EXPLANATION OF G-15 ECO's --- 970-1096

SUBJECT: G-15 ECO's (Revision 1)

DATE: 7 January 1960

The purpose of this memorandum is primarily to provide detail drawings of all wiring changes affecting the G-15 since machine Serial No. 210.

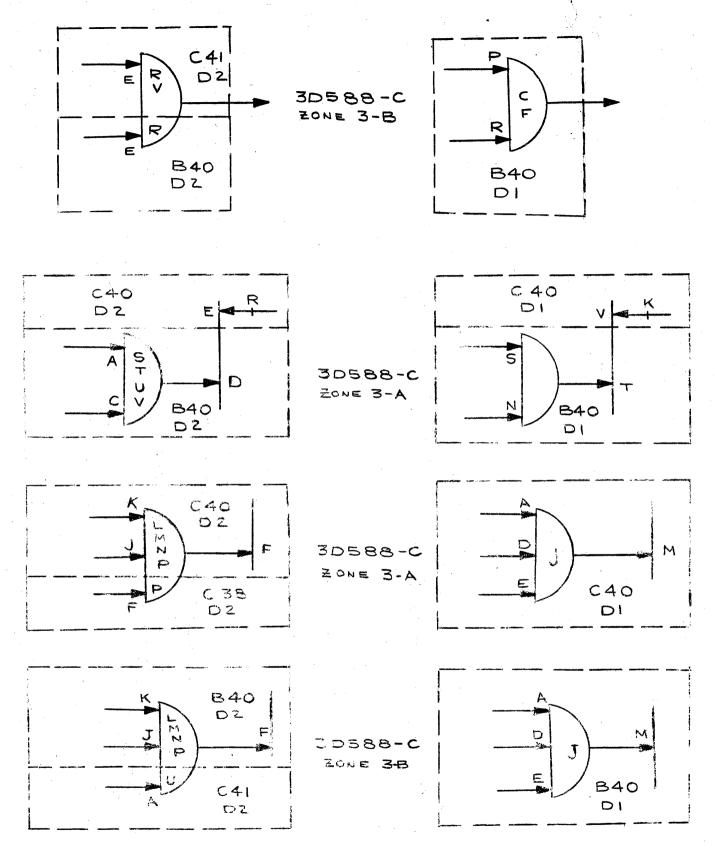
The drawings contained in this section describe wiring changes incorporated in ECO's 970, 978 and 1010 which involved no changes in logic.

The reasons for these changes are as follows:

To provide additional diodes by replacing the following D2 packages with D1 packages:

B40, C40, C39, C37

2) To provide additional cathode followers by replacing the following CF1 packages with CF3 packages:

C4, C5 and K5.

- 3) To free cathode follower location B3 in order to replace it with a flip—flop which will be used to provide the AS and OH signal.
- 4) To rectify some minor errors which existed in previous ECO's.

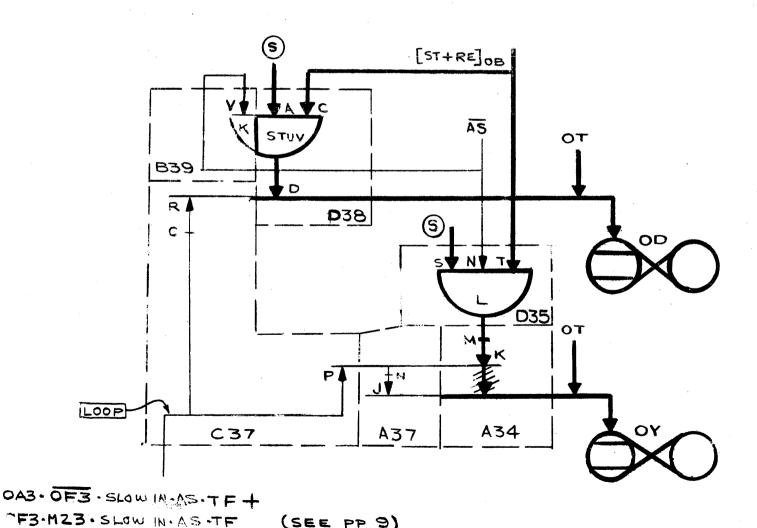
The additions indicated in the drawing below were included in ECO 970 and 978. One other ''AND'' gate which set OY was also added but was later removed by ECO 1053.

This term was AS·STOPOB·[ST + RE]OB·(S)·OD·

Section III

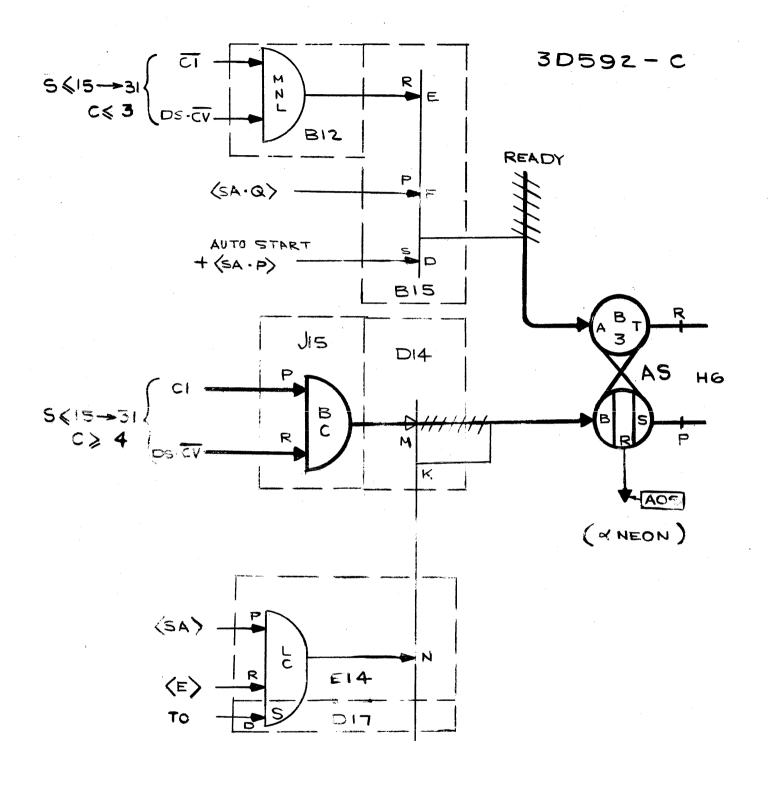
The set and reset terms for the AS flip-flop are a result of the combined requirements of the PR-2 and the alphanumeric typewriter.

The detail drawing on the following page indicates the terms added by PR-2 and those added by alphanumeric. The ready signal used to reset AS was removed by the alphanumeric typewriter and applied to the reset of OH.

Section IV

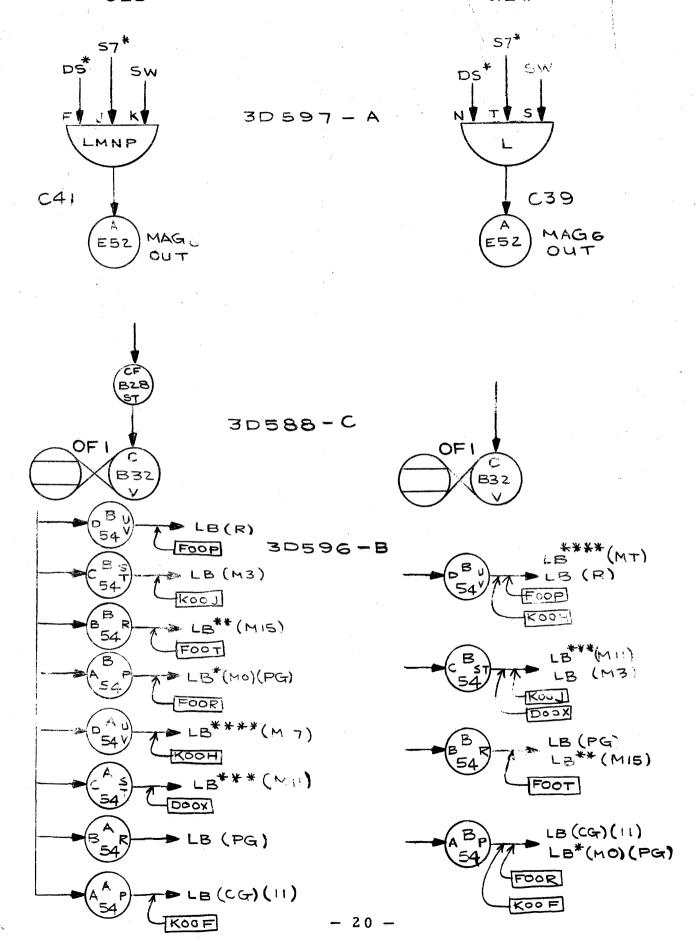
The drawings contained in this section describe wiring changes incorporated in ECO's 1020, 1029, 1038 and 1053 which involved no changes in logic.

The purpose of these changes was to provide additional diodes and cathode followers.
